**Addendum No. 2
January 20, 2023**

Project: Baltic High School Addition
Baltic, South Dakota
Arch Project No. 2957

Architect: Architecture Incorporated

3 FOUNDATION WALL - AREA H
3/4' x 1'-0'

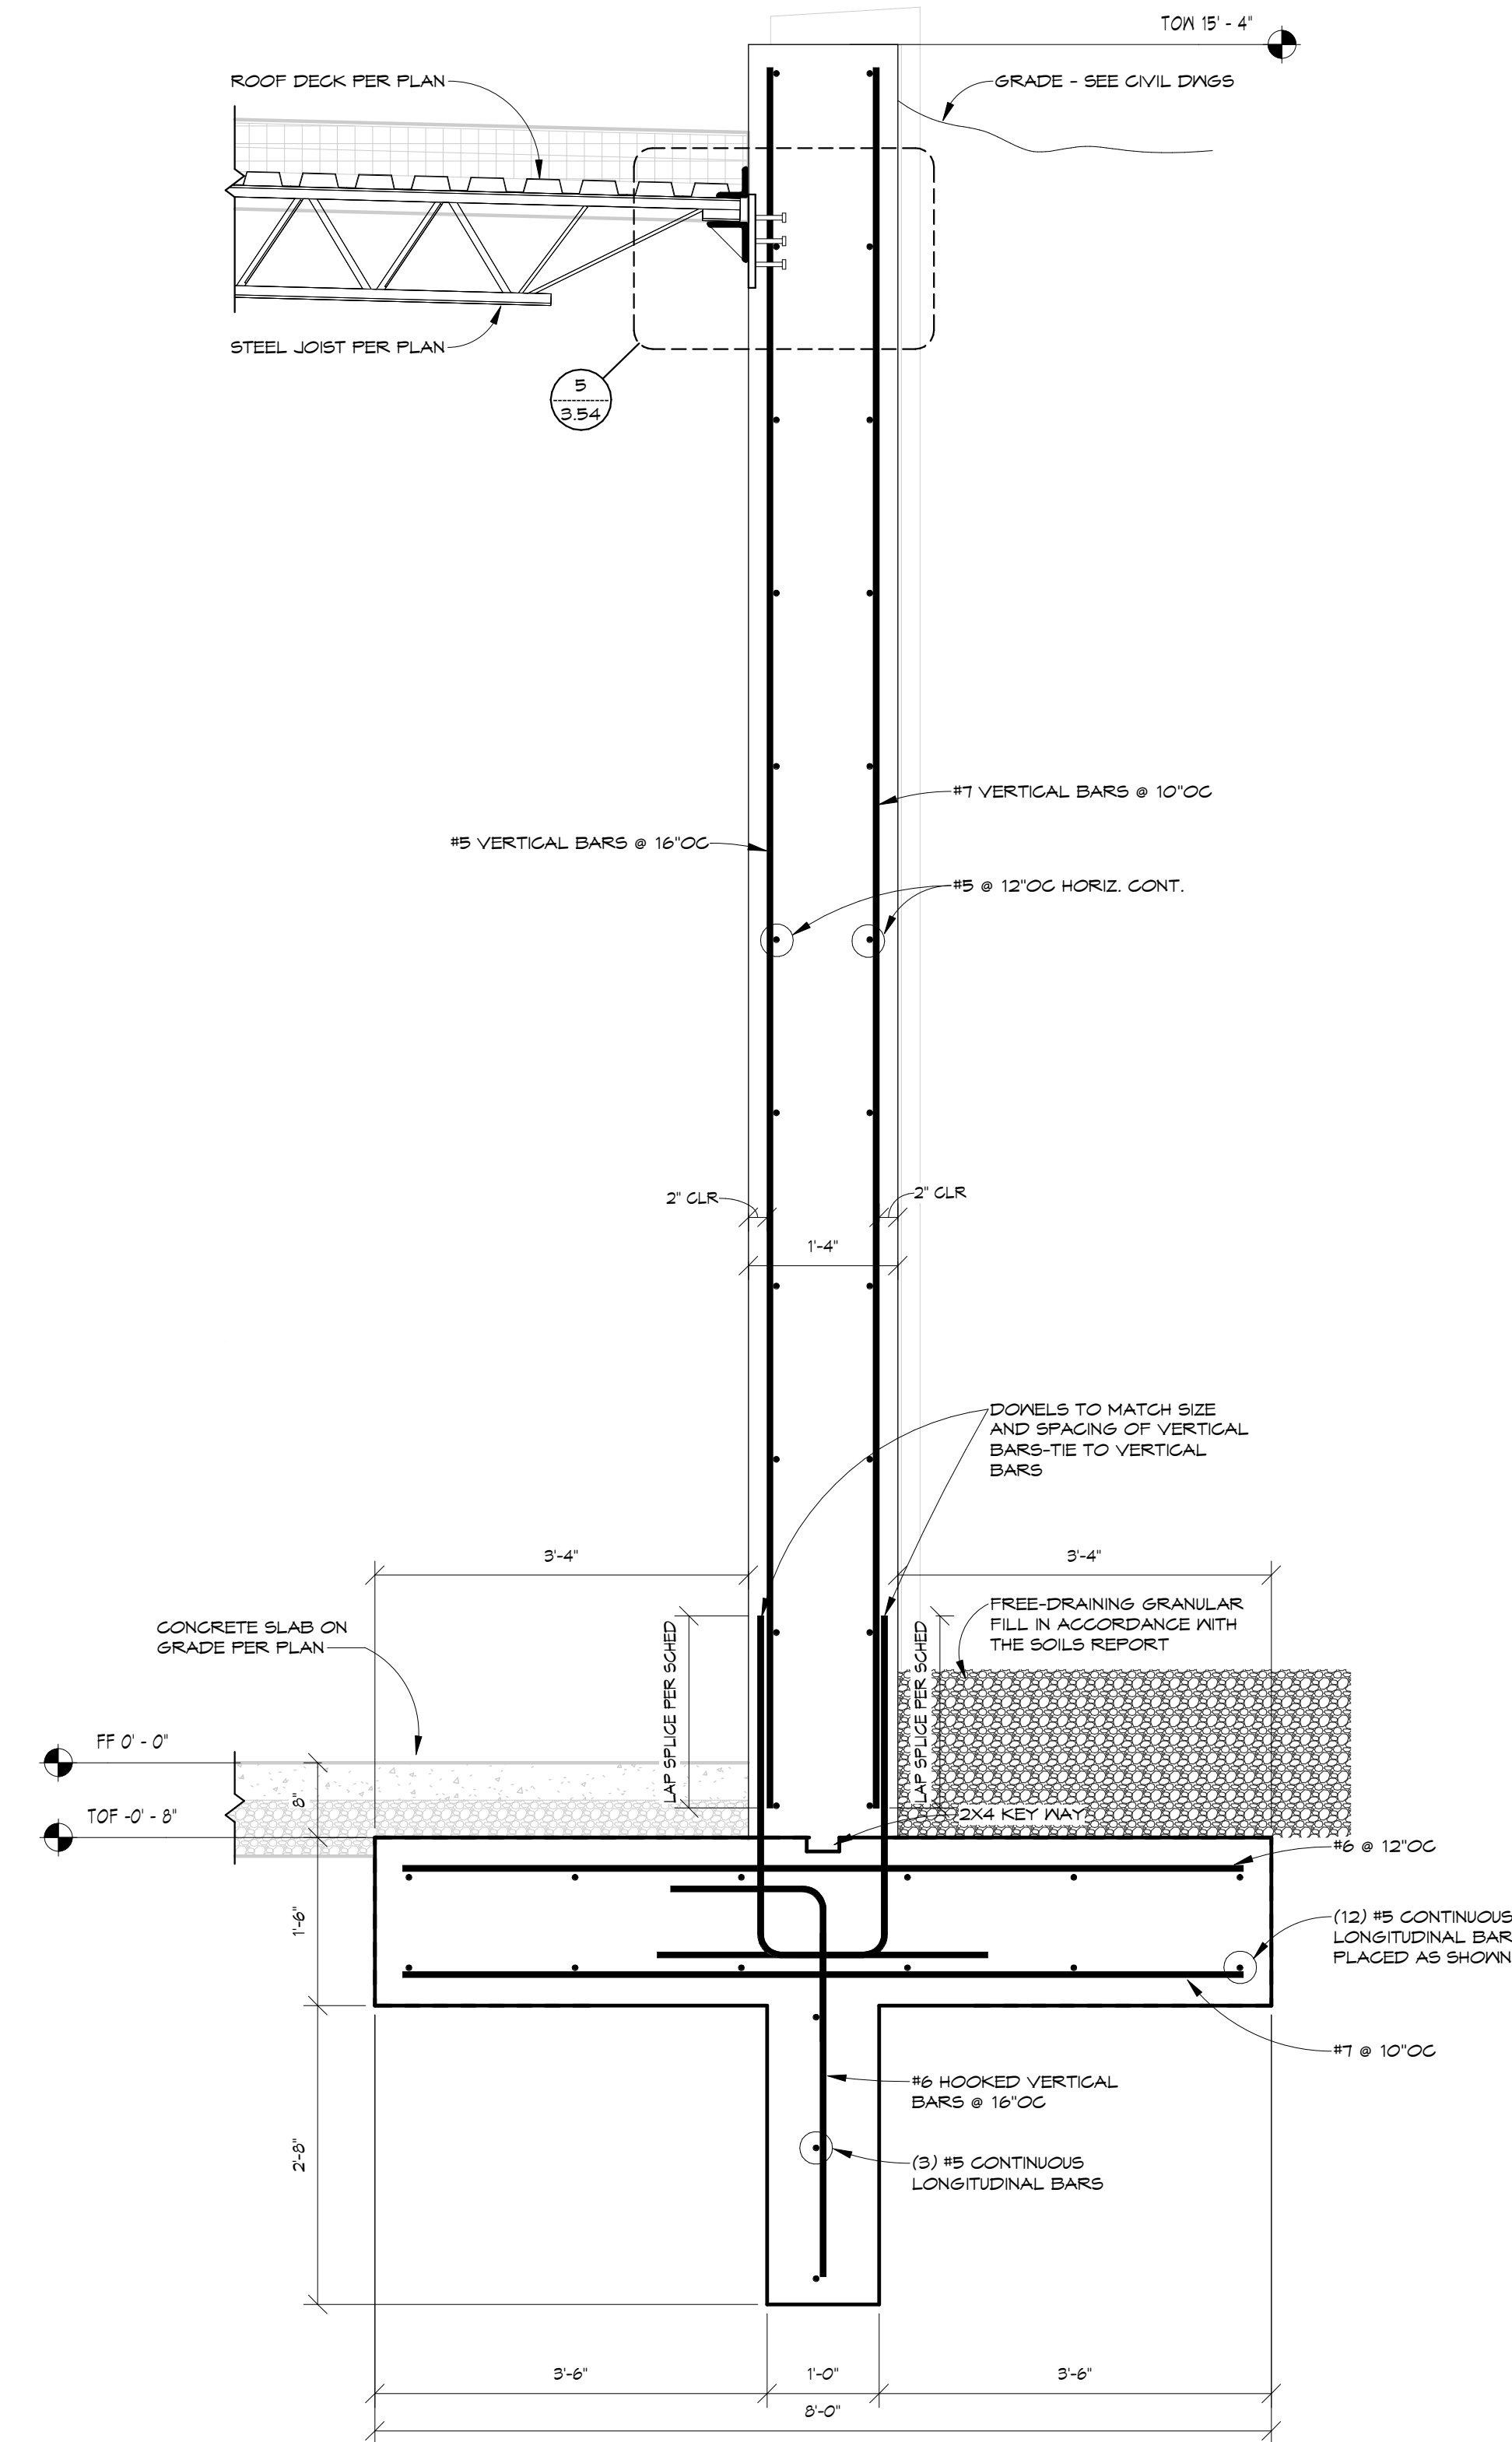
- a) Reference structural Detail 5/3.41: Add footing width dimension of “2’-4” UNO” in lieu of “SEE PLAN”.
- b) Omit structural Detail 6/3.41 in its entirety; not applicable.
- c) Revise structural Detail 7/3.41 as indicated per revised drawing Sheet 3.41.
- d) Reference revised drawing Sheet 3.41, revision dated 1-20-23, attached to the end of this addendum for structural changes listed above.

3.65

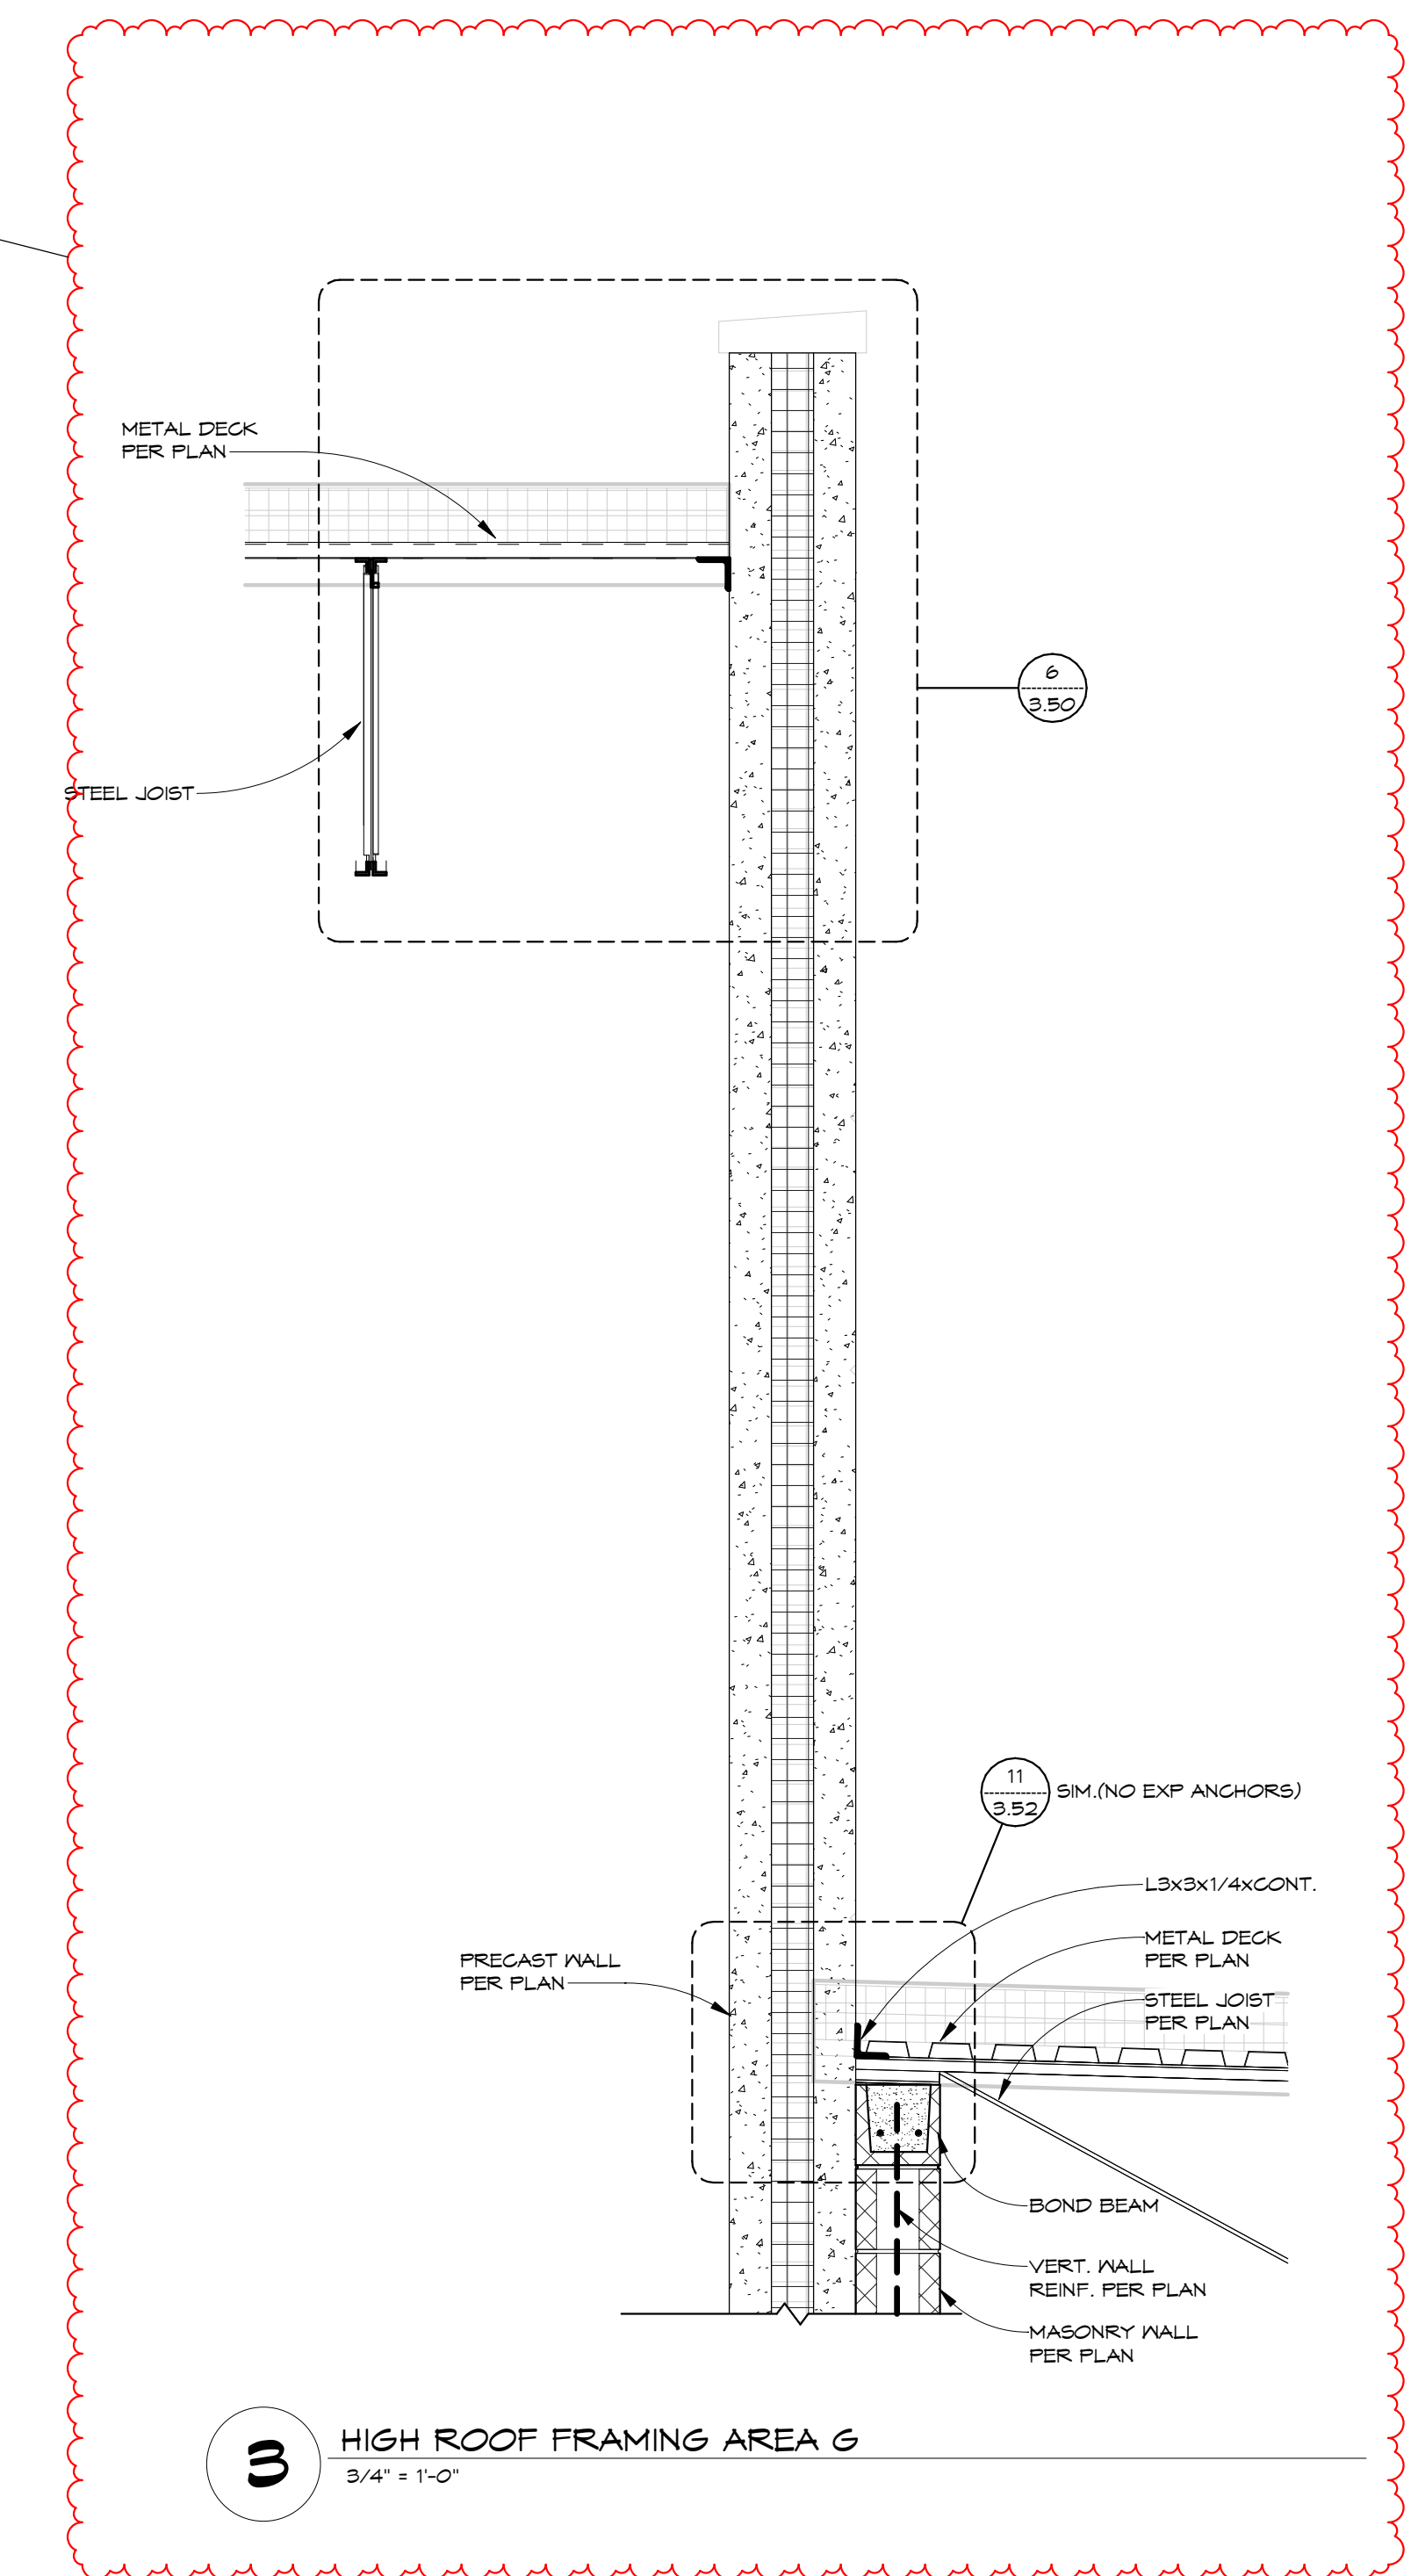
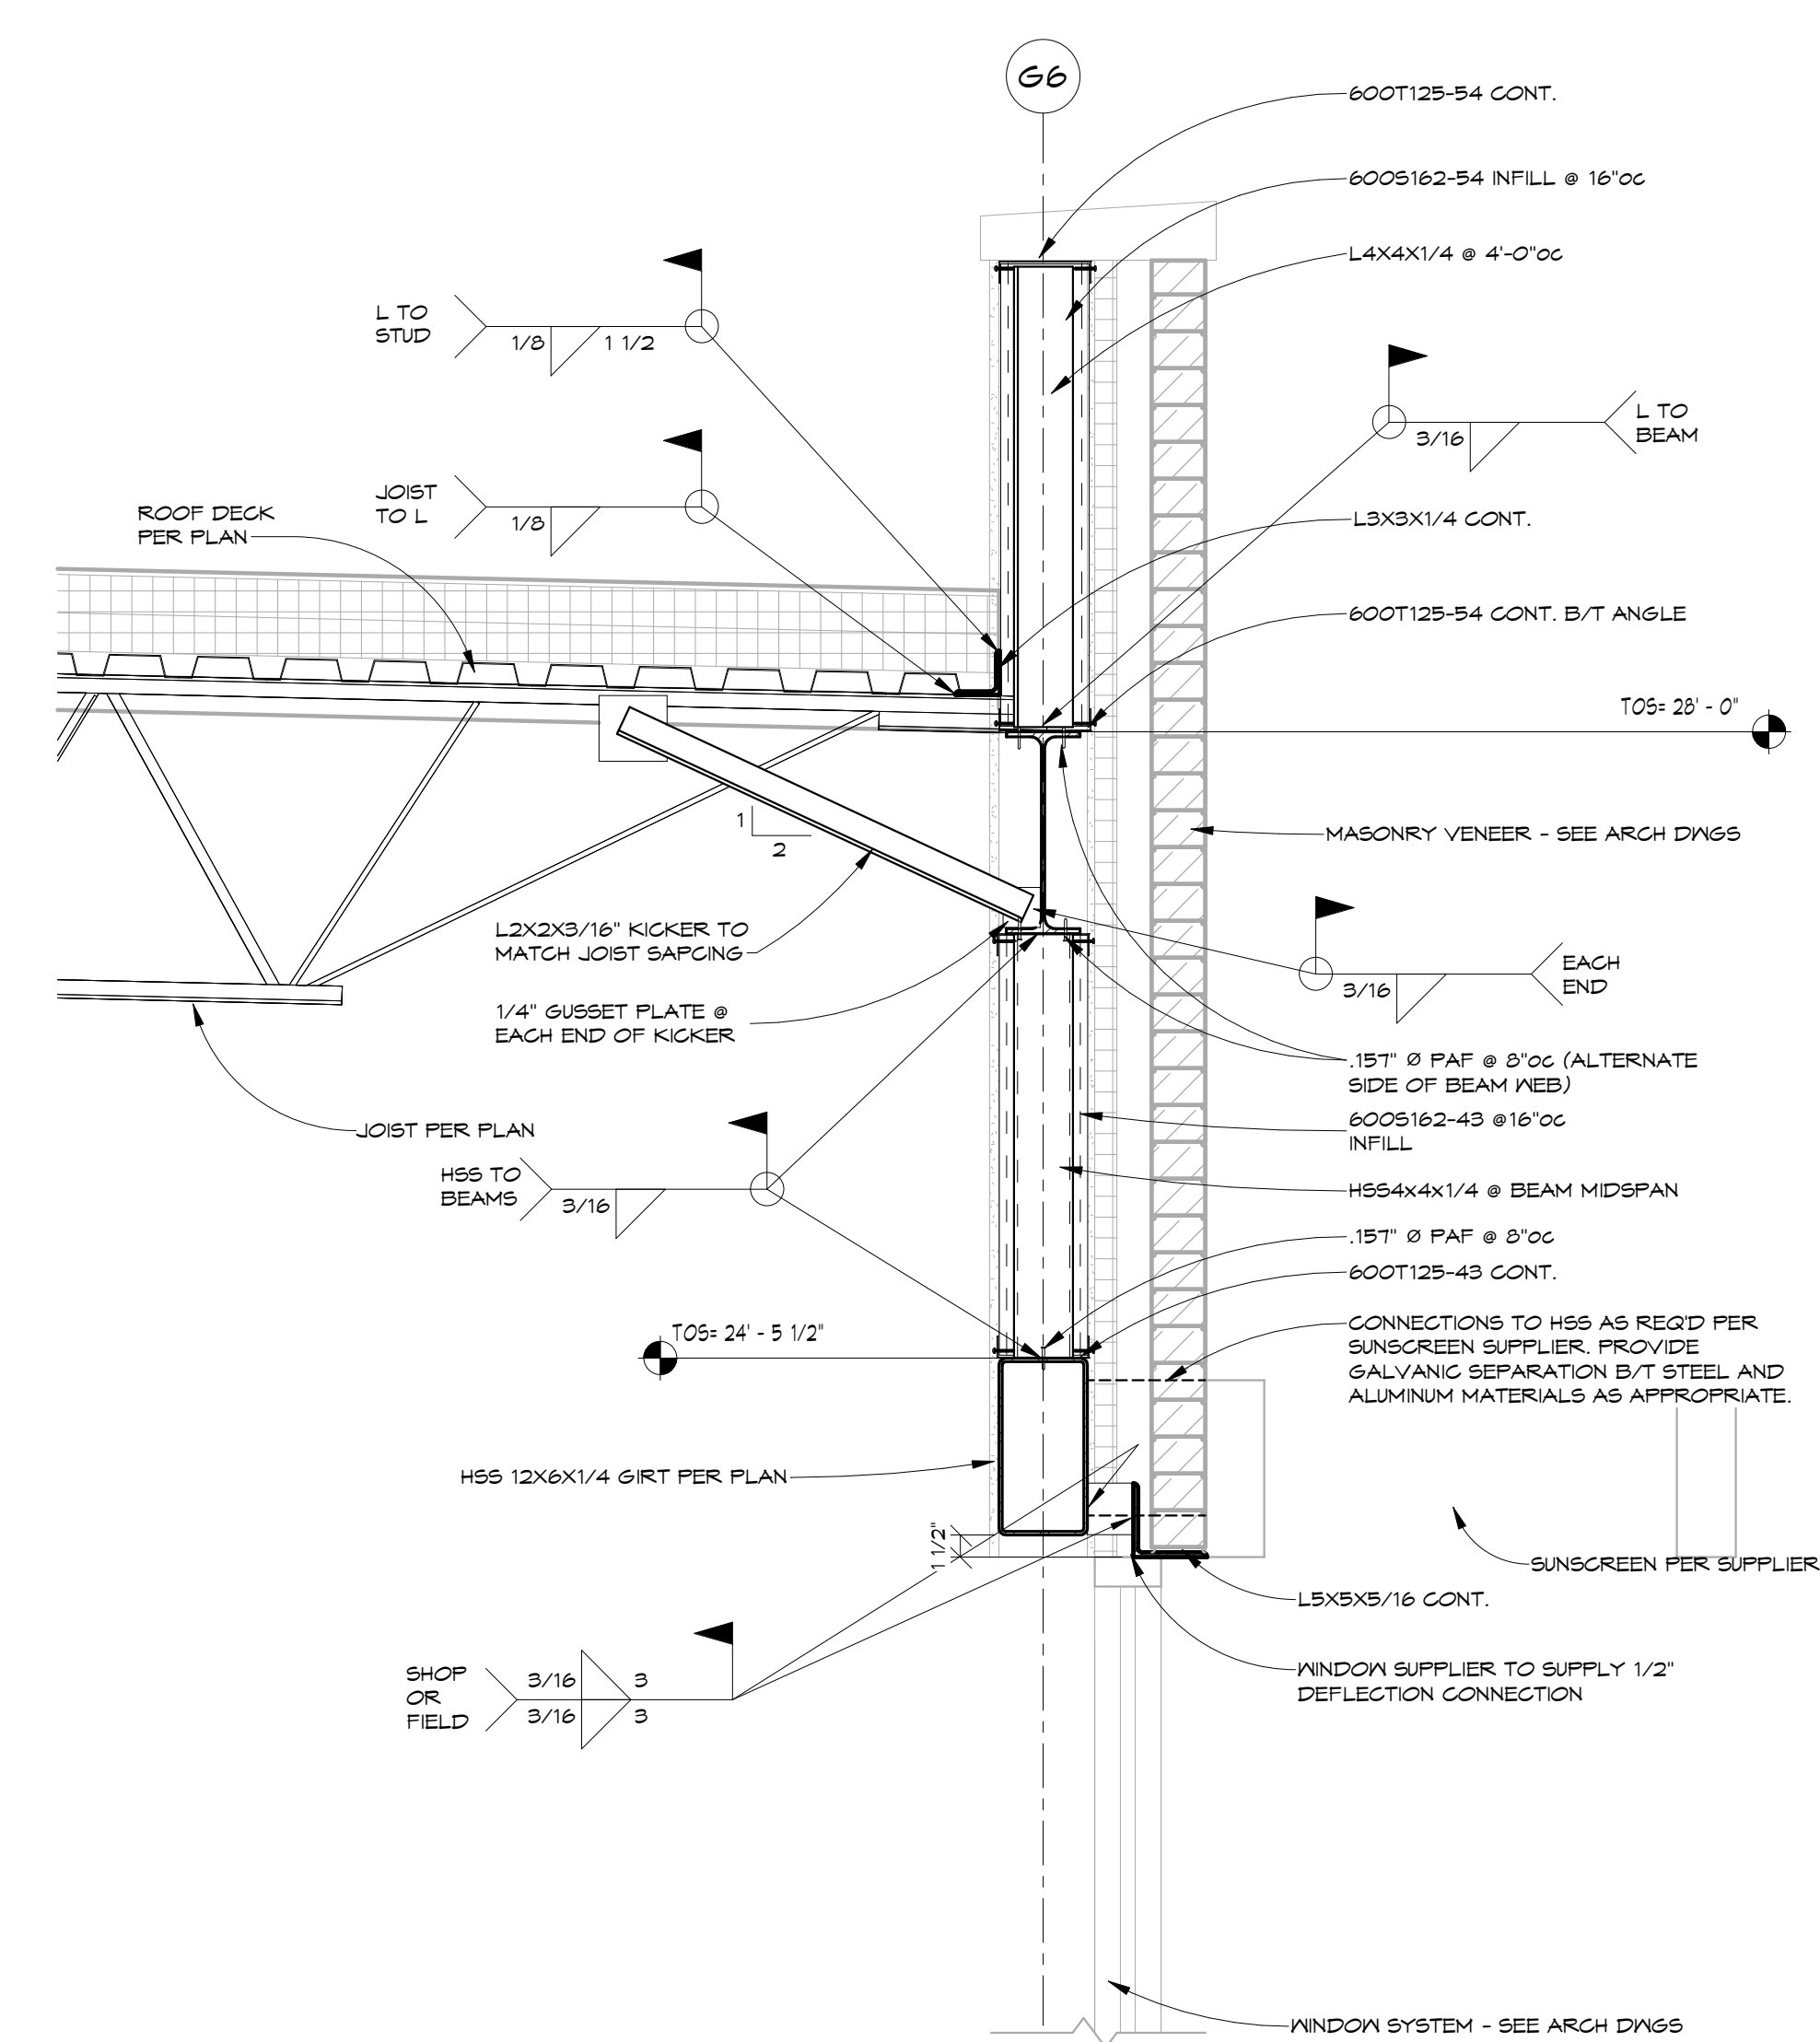
- a) Revise structural Detail 1/3.65 as indicated per revised drawing Sheet 3.65.
- b) Revise structural Detail 3/3.65 as indicated per revised drawing Sheet 3.65.
- c) Revise structural Detail 4/3.65 as indicated per revised drawing Sheet 3.65.
- d) Reference revised drawing Sheet 3.65, revision dated 1-20-23, attached to the end of this addendum for structural changes listed above.
